May 18, 2017
GZA File No. 05.0043654.00-C

Re: Site Investigation Report (SIR) Addendum
Former Tidewater Facility
RIDEM File No. SR-26-0934A
RIDEM Case Number: 95-022
Tidewater Street
Pawtucket, Rhode Island

SIR COMMENT LETTER

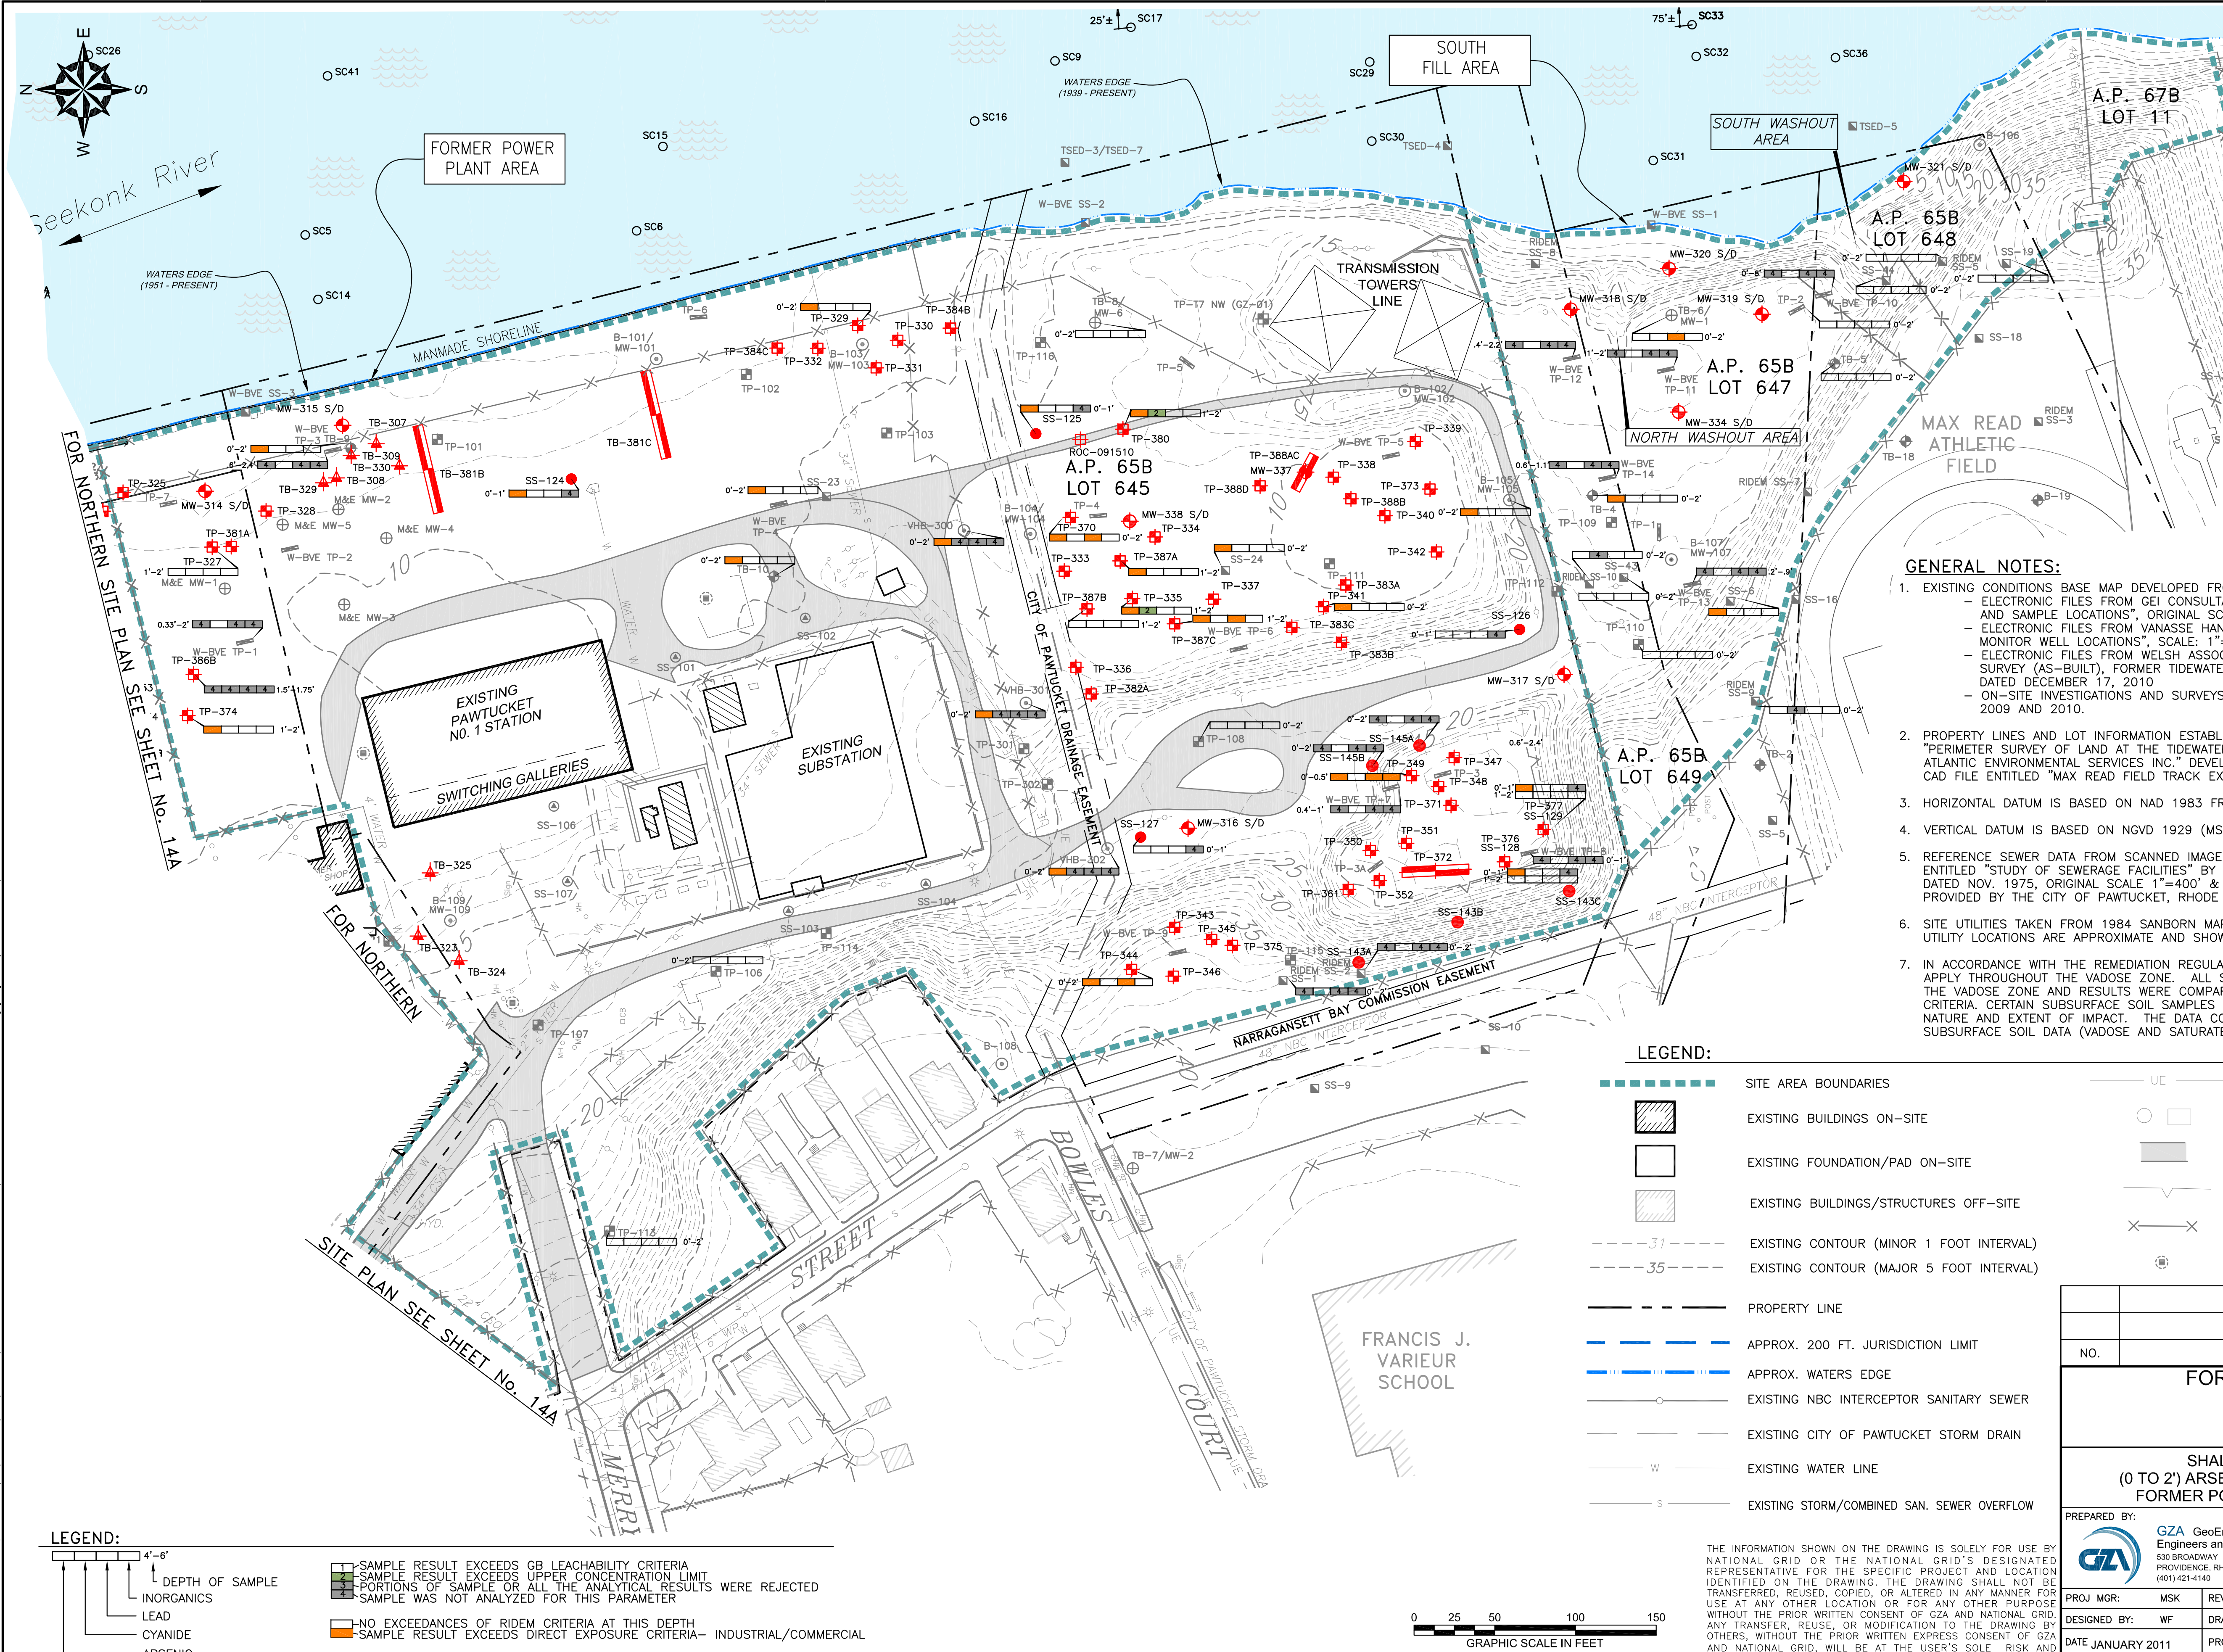
Regarding the January 11, 2011, Site Investigation Data Report (SIDR), Please correct the title of Figure 14B to replace the word "Subsurface" with "Surface."

See attached Figure 14B, Shallow Surface Soil Distribution (0 to 2') Arsenic, Cyanide, Lead, Inorganics Impacts, Former Power Plant Area and South Fill Area.
